UNITED STATES PATENT AND TRADEMARK OFFICE

APPLICATION NO.	FILING DATE	FIRST NAMED INVENTOR	ATTORNEY DOCKET NO.	CONFIRMATION NO.
10/583,817	12/08/2008	Lars Jorneus	NOBELB.244NP	8735

Office Action Summary	Application No. 10/583,817	Applicant(s) JORNEUS ET AL.	
	Examiner HEIDI M. EIDE	Art Unit 3732

DETAILED ACTION

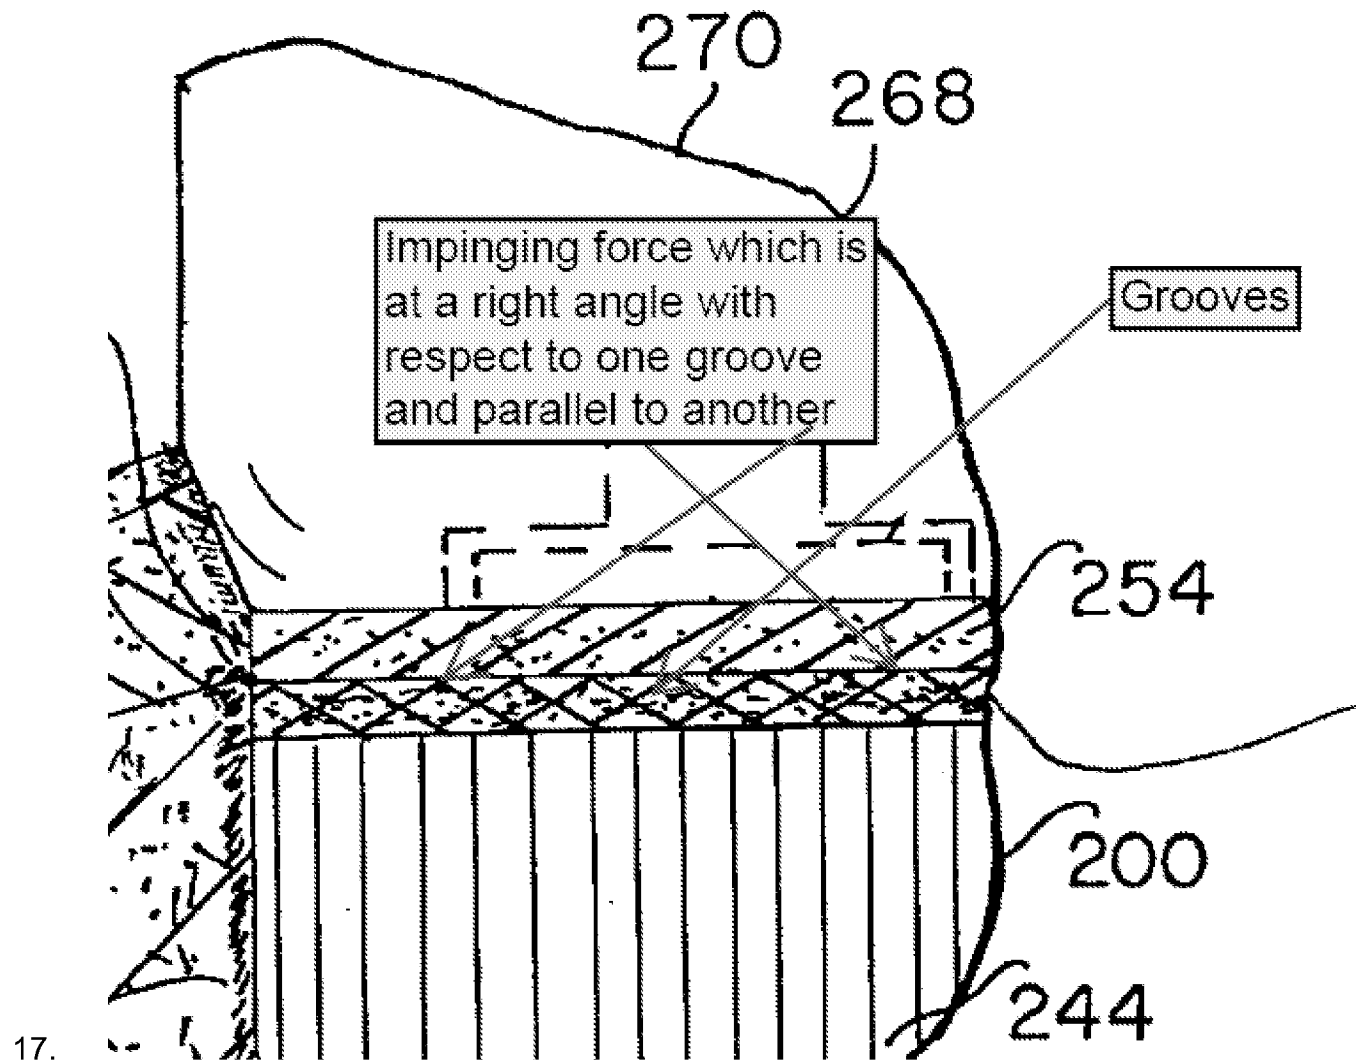
15. Claims 1-2 and 6-14 rejected under 35 U.S.C. 103(a) as being unpatentable over Ricci et al. (6,419,491).

16. Ricci teaches a dental implant for insertion into a hole formed in a jaw bone and exposure to an impinging force or impinging forces (fig. 28), the dental implant comprising peripherally extending surfaces 253 which are arranged at upper/outer portion of the dental implant and are configured to be places against a jaw bone part at an outlet opening of the hole (fig. 28, col. 11, ll. 34-37), wherein each of the peripherally extending surfaces is provided with a pattern of grooves in which greater than 20% of the grooves are capable of being configured so that in the hole the grooves extend substantially at right angles to or parallel to the impinging forces when theses impinging

forces assume principal direction differing from the longitudinal direction of the implant (fig. 28, see figure below for further explication).
